# TECH EXCHANGE

**SUBJECT: 2017 FZ10, 2018~2021 MT-10, AND 2016~2018 YZF-R1S**

**— Revised Oil Pan Tightening Torque and New Oil Pan Gasket**

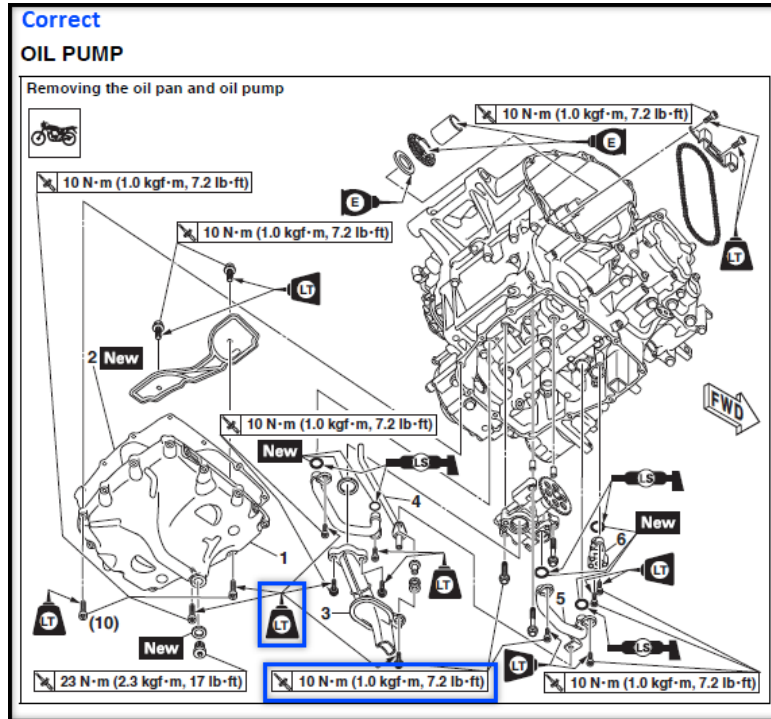
The Service Manuals for the 2017 FZ-10 (LIT-11616-30-05), 2018~2021 MT-10 (LIT-11616-31-48), 2016 YZF-R1S (LIT-11616-29-36), and 2017~2018 YZF-R1S (LIT-11616-30-62) have been updated to show the revised tightening torque and proper Loctite® application. The Service Manuals in the Knowledge Center on the Yamaha Dealer System (YDS) have been updated to show the correct and complete information. The revised torque value is intended to be used with the superseded oil pan gasket which is intended to reduce the chance of oil weepage.

<b>Incorrect</b>				
Oil pan bolt	M6	3	12 Nm (1.2 m-kgf, 8.7 ft-lbf)	
Oil pan bolt	M6	9	12 Nm (1.2 m-kgf, 8.7 ft-lbf)

<p><b>Incorrect</b></p> <p><b>INSTALLING THE OIL PAN</b></p> <p>1. Install:</p> <ul style="list-style-type: none"> <li>• Oil pan gasket <b>New</b></li> <li>• Oil pan</li> <li>• Oil pan bolt</li> </ul> <p>2. Tighten:</p> <ul style="list-style-type: none"> <li>• Oil pan bolt</li> </ul> <div style="border: 1px solid black; padding: 5px; margin: 5px 0;">  <p><b>Oil pan bolt</b> 12 Nm (1.2 m-kgf, 8.7 ft-lbf)</p> </div> <p><b>TIP</b></p> <ul style="list-style-type: none"> <li>• Apply locking agent (LOCTITE®) to the bolts installed in the bolt holes marked with arrows "a" on the oil pan.</li> <li>• Tighten the oil pan bolts in stages and in a crisscross pattern.</li> </ul> 	<p><b>Correct</b></p> <p><b>INSTALLING THE OIL PAN</b></p> <p>1. Install:</p> <ul style="list-style-type: none"> <li>• Oil pan gasket <b>New</b></li> <li>• Oil pan</li> <li>• Oil pan bolt (x 12)</li> </ul> <p><b>TIP</b></p> <p>Tighten the oil pan bolts in stages and in a crisscross pattern.</p> <p>2. Tighten:</p> <ul style="list-style-type: none"> <li>• Oil pan bolt</li> </ul> <div style="border: 1px solid black; padding: 5px; margin: 5px 0;">  <p><b>Oil pan bolt</b> 10 N-m (1.0 kgf.m, 7.2 lb-ft) LOCTITE®</p> </div>

<b>Correct</b>				
Oil pan bolt	M6	12	10 Nm (1.0 m-kgf, 7.2 ft-lbf)
